# **APPENDIX E.8**

#### RE: Water Licence 2AM-MRY1325 February 2020 Inspection – Follow Up

#### **INSPECTION FORM**

Table 1 – Baffinland Responses to CIRNAC Water Licence Inspection

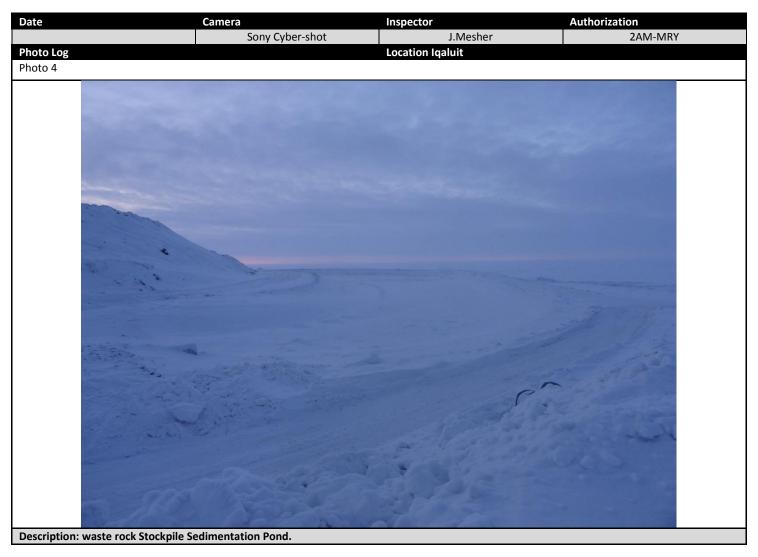
- b) All the containment ponds associated with this structure appeared to be pumped out to prepare for Freshet. See photo 1 for MP-05 and Photo for MP-06.

b) All the containment ponds associated with this structure appeared to be pumped out to prepare for Freshet. See photo 1 for MP-05 and Photo for MP-06.	CIRNAC's comment is noted. No update is required for this finding.
